**Responses to Comments**  
on the  
**Draft Environmental Analysis**

for the  
**Low Carbon Fuel Standard and  
Alternative Diesel Fuel  
Regulations**

**Released September 21, 2015**  
to be considered at the  
**September 24, 2015 Board Hearing**

**Figure 2. There Are No Detectable Differences Among Feedstock Types Once NOx Emissions Are Adjusted to Constant CN**

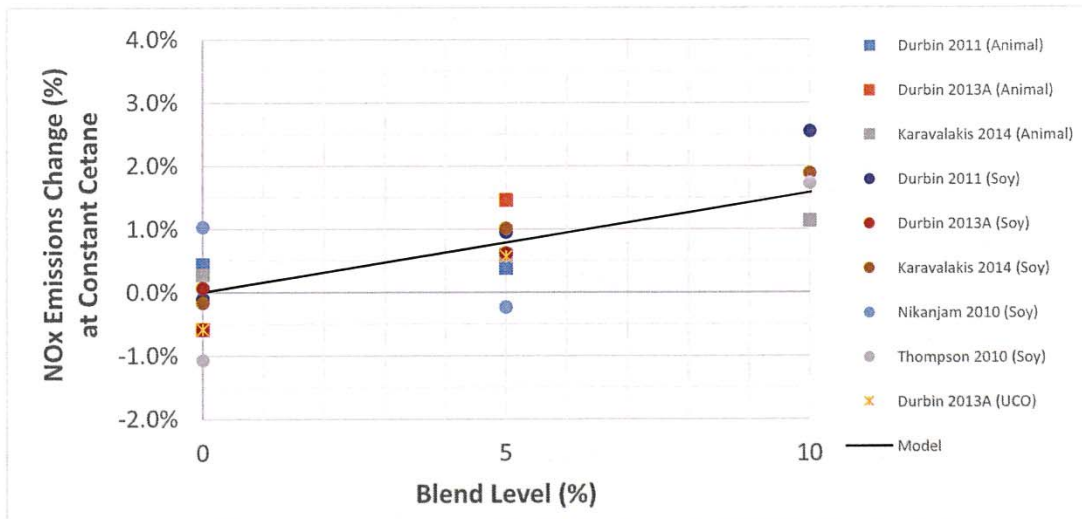
To demonstrate these conclusions, Figure 2 presents NOx emissions as a function of blend level for all fuels used to estimate the model once NOx emissions are adjusted for the CN change observed for each blend. For example, if an animal blend increased CN, then its NOx impact is increased as we return it to the base fuel CN. If a soy blend decreases CN, then its NOx impact is decreased as we return it to the base fuel CN. Once adjusted, percent changes in emissions are calculated. As seen in the figure, there is no discernable difference among feedstock types once CN changes are taken into account. Animal and soy blends scatter on both sides of the regression line, indicating that they obey the same blend level model.

**Figure 3. The Impact of Biodiesel on NTDE NOx Emissions**

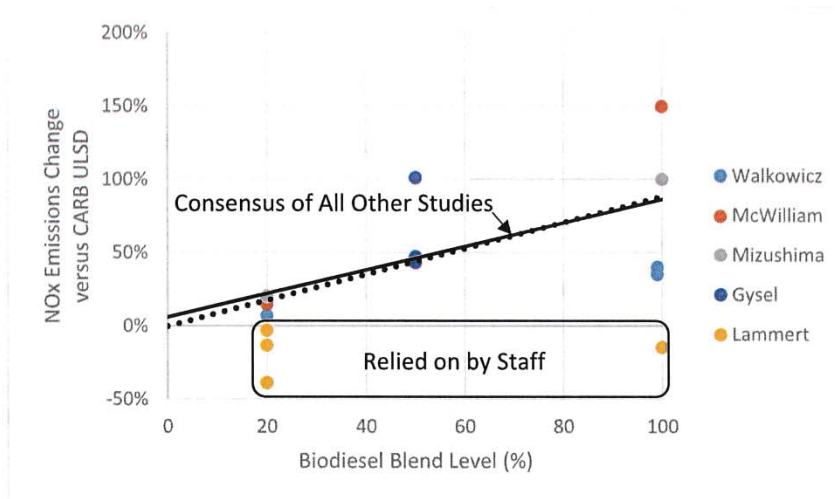
Figure 3 summarizes the impact of biodiesel on NTDE NOx emissions at all blend levels. The four studies (excluding Lammert 2012) establish a linear relationship between NOx emissions and blend level. The first trend line (solid black) passes very nearly through the origin without being constrained to do so. The second trend line (dotted black) is constrained to pass through the origin. While there is substantial scatter around the trend lines, the consensus of the four studies is that biodiesel increases NOx by 18-22% at B20, by 45-50% at B50, and by 90-100% at B100.
